Access Compliance Report

Public Rights-of-Way

(Curb Ramps)

Intersection ID: 51369	Main Street: UNIVERSITY_CITY_BV	Cross Street: IKEA_BV	Location: NW
ADA ID: 43E66077F996	Ramp Type: Perp	Initial Pass/Fail: Fail	Overall Compliance: No
Severity Score: 1.25			
Codes/Mitigation Info/Possible Solution		Field Measurements/Component Compliance

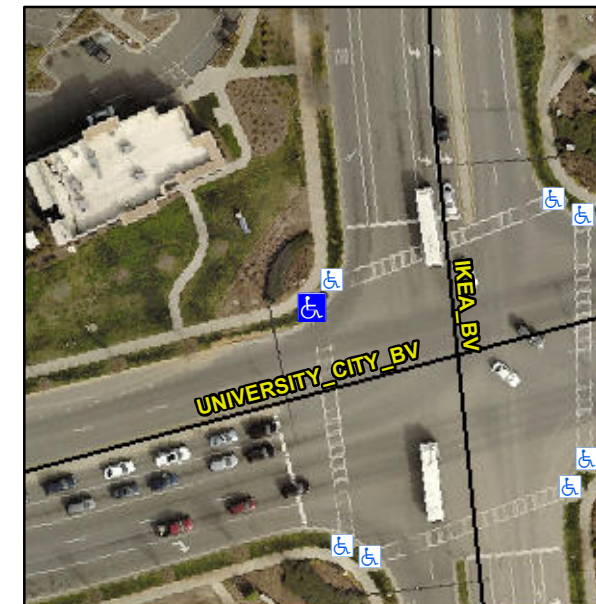
Not Found, R304.5.3

Compliance	Description	Data	Compliance	Description	Data
N/A	Ramp Length (in)	96.0	Yes	Ramp Slope (%)	6.0
Yes	Ramp Width (in)	48.0	No	Ramp XSlope (%)	2.1
N/A	Flare Type LT	N/A	N/A	Flare Type RT	N/A
N/A	Flare Slope LT (%)	N/A	N/A	Flare Slope RT (%)	N/A
N/A	Flare Traversable LT?	N/A	N/A	Flare Traversable RT?	N/A
N/A	Landing Length (in)	N/A	N/A	DWS Provided?	N/A
N/A	Landing Width (in)	N/A	N/A	DWS Contrast?	N/A
N/A	Landing Slope (%)	N/A	N/A	DWS Length (in)	N/A
N/A	Landing X Slope (%)	N/A	N/A	DWS Full Width?	N/A
N/A	Landing Curb? (Y/N)	N/A	N/A	DWS Offset (in)	N/A
N/A	Shared Landing?	N/A			
N/A	Gutter Ponding?	N/A	N/A	Gutter Slope (%)	N/A
N/A	Gutter Lip Ht (in)	N/A	N/A	Gutter X Slope (%)	N/A
N/A	Painted X Walk1?	Yes	N/A	Painted X Walk2?	N/A
	X Walk 1 Direction	To S		X Walk 2 Direction	N/A
N/A	X Walk 1 Width (in)	84.0	N/A	X Walk 2 Width (in)	N/A
	X Walk 1 Slope (%)	3.9		X Walk 2 Slope (%)	N/A
	X Walk 1 X Slope (%)	0.7		X Walk 2 X Slope (%)	N/A

Remove & Replace Entire Ramp.
